Access Compliance Report

Public Rights-of-Way

(Curb Ramps)

Intersection ID: 11037	Main Street: SUMTER_AV	Cross Street: WESTBROOK_DR	Location: S
ADA ID: 728DA4C8C55D	Ramp Type: PerpDiag	Initial Pass/Fail: Fail	Overall Compliance: No
Codes/Mitigation Info/Possible Solution		Field Measurements/Component Compliance

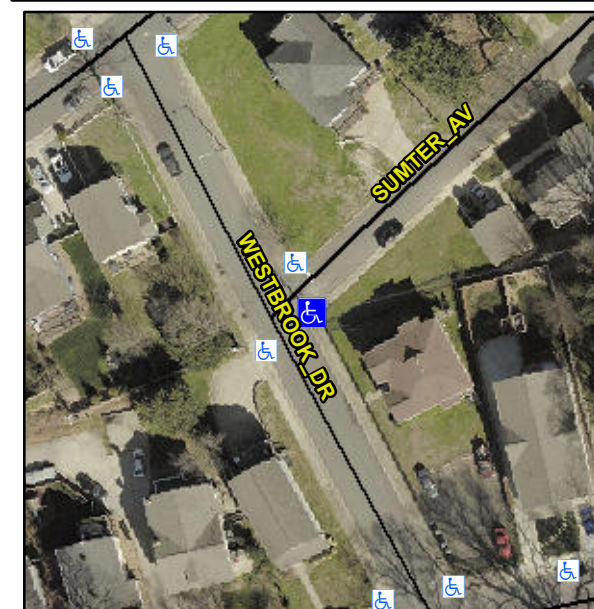
Not Found, R304.5.1, R304.2.2, R304.5.3

Compliance	Description	Data	Compliance	Description	Data
N/A	Ramp Length (in)	52.0	No	Ramp Slope (%)	12.5
No	Ramp Width (in)	24.0	No	Ramp XSlope (%)	3.1
N/A	Flare Type LT	N/A	N/A	Flare Type RT	N/A
N/A	Flare Slope LT (%)	N/A	N/A	Flare Slope RT (%)	N/A
N/A	Flare Traversable LT?	N/A	N/A	Flare Traversable RT?	N/A
N/A	Landing Length (in)	N/A	N/A	DWS Provided?	N/A
N/A	Landing Width (in)	N/A	N/A	DWS Contrast?	N/A
N/A	Landing Slope (%)	N/A	N/A	DWS Length (in)	N/A
N/A	Landing X Slope (%)	N/A	N/A	DWS Full Width?	N/A
N/A	Landing Curb? (Y/N)	N/A	N/A	DWS Offset (in)	N/A
N/A	Shared Landing?	N/A			
N/A	Gutter Ponding?	N/A	N/A	Gutter Slope (%)	N/A
N/A	Gutter Lip Ht (in)	N/A	N/A	Gutter X Slope (%)	N/A
N/A	Painted X Walk1?	No	N/A	Painted X Walk2?	No
	X Walk 1 Direction	To N		X Walk 2 Direction	To W
N/A	X Walk 1 Width (in)	N/A	N/A	X Walk 2 Width (in)	N/A
	X Walk 1 Slope (%)	2.0		X Walk 2 Slope (%)	7.8
	X Walk 1 X Slope (%)	2.7		X Walk 2 X Slope (%)	2.5

Remove & Replace Curb Ramp With Two New Directional Ramps or Equivalent.
